**HEADS CREEK RESERVOIR DAM REHABILITATION  
ADDENDUM NO. 4  
Issued March 21, 2022**

City of Griffin  
Solicitation Number: 22-007

HEADS CREEK RESERVOIR  
 DAM REHABILITATION

EROSION, SEDIMENTATION,  
 AND POLLUTION CONTROL  
 PLAN PHASE 3

| DRAWING NUMBER: | ESC04      |

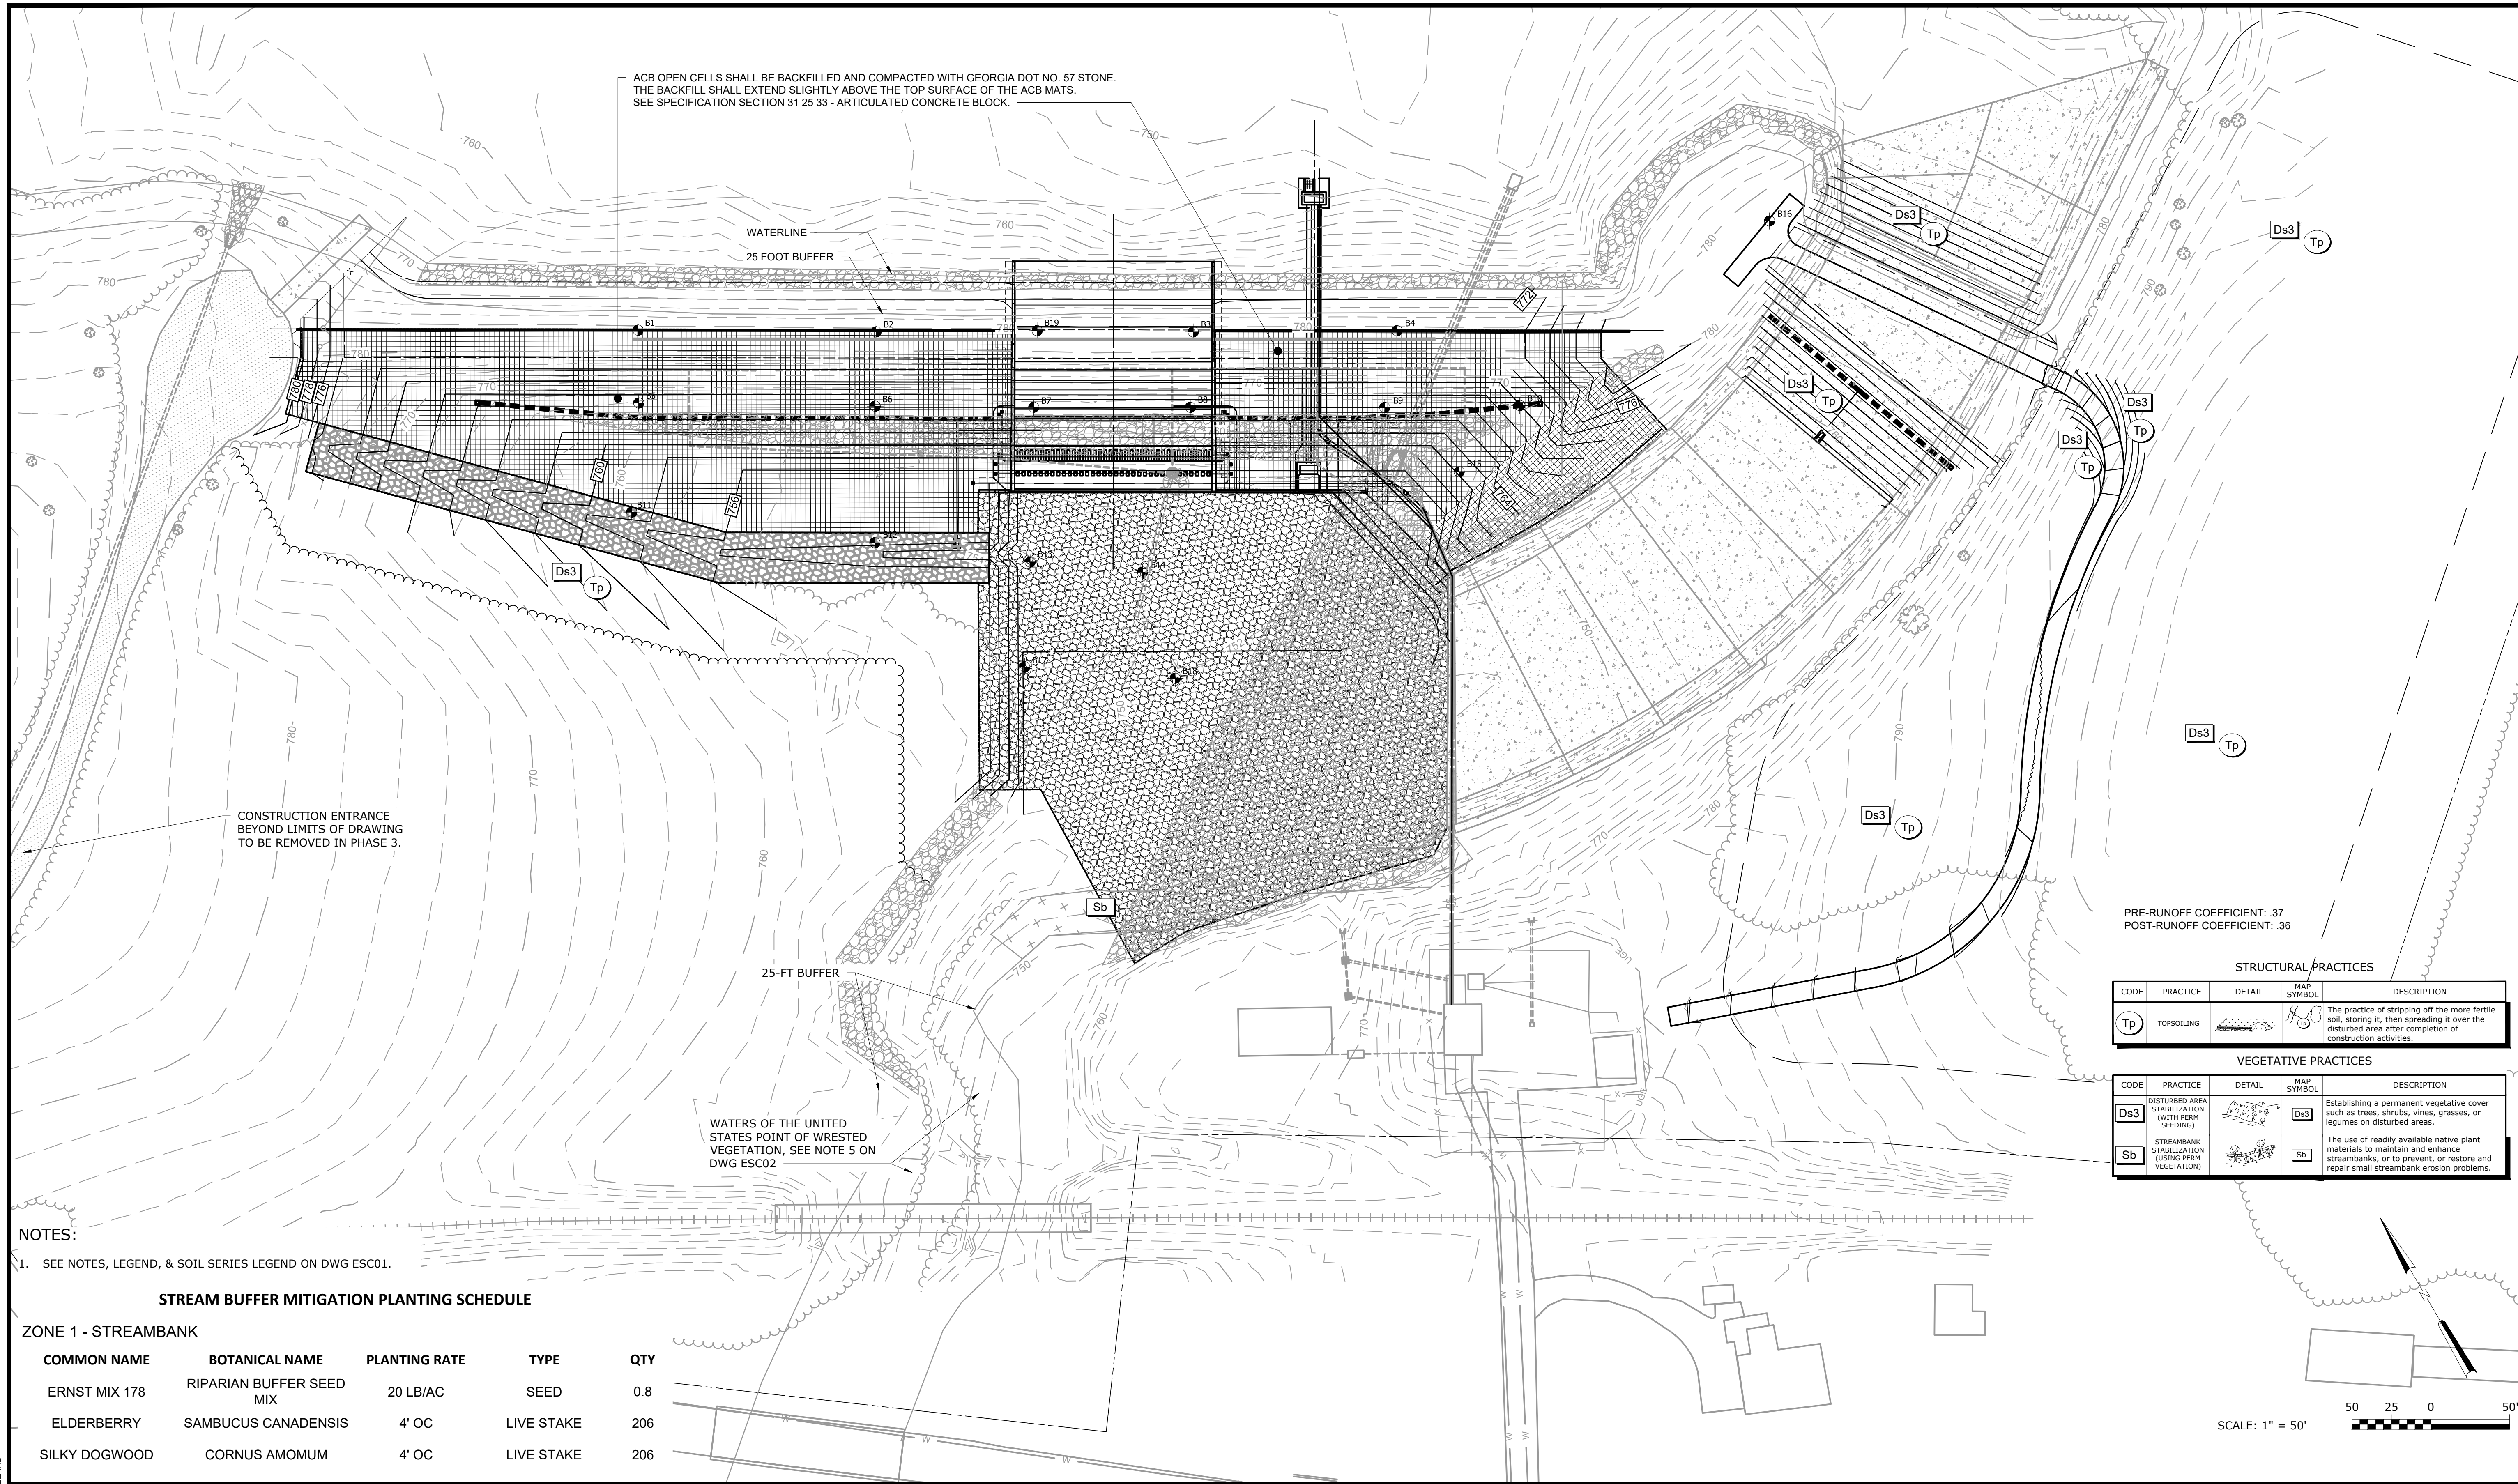
18. Specification Section 31 35 33 Part 3.06.N states the open cells in the ACB system shall be backfilled with 57 stone. Plan sheet ESC04 shows Tp (Topsoil) and Ds3 (Permanent seeding) is to be placed in the areas occupied by the ACB. On the contrary, details on sheet C51 do not show topsoil on top of the ACB system. Please confirm that there is topsoil and permanent seed on top of the ACB (that will have its open cells backfilled with 57 stone). If this is not the case and the ACB system with 57 stone backfill is to be exposed and final elevation is 773.8, please revise drawing ESC04 and remove the Tp and Ds3 designation in these areas.

1. Erosion, Sedimentation, and Pollution Control Plans – Drawing ESC04 is Reissued through this Addendum. Below is a summary of the changes. Bidders should thoroughly review the plans.

- a. Annotations indicating the ACB are to be backfilled with topsoil and grassed have been removed.

- b. The following callout has been added for the ACB:

- c. The Pre-Runoff and Post-Runoff Coefficients were updated.

**Response: The ACB open cells shall be backfilled and compacted with Georgia DOT No. 57 Stone with the backfill extending slightly above the top surface of the ACB mats as indicated in the referenced specification section.**

**Drawing ESC04 will be Reissued through this Addendum as indicated below in Section E.**

ACB OPEN CELLS SHALL BE BACKFILLED AND COMPACTED WITH GEORGIA DOT NO. 57 STONE.

THE BACKFILL SHALL EXTEND SLIGHTLY ABOVE THE TOP SURFACE OF THE ACB MATS.

SEE SPECIFICATION SECTION 31 25 33 – ARTICULATED CONCRETE BLOCK.

ACB OPEN CELLS SHALL BE BACKFILLED AND COMPACTED WITH GEORGIA DOT NO. 57 STONE.  
 THE BACKFILL SHALL EXTEND SLIGHTLY ABOVE THE TOP SURFACE OF THE ACB MATS.  
 SEE SPECIFICATION SECTION 31 25 33 - ARTICULATED CONCRETE BLOCK.

PRE-RUNOFF COEFFICIENT: .37  
 POST-RUNOFF COEFFICIENT: .36
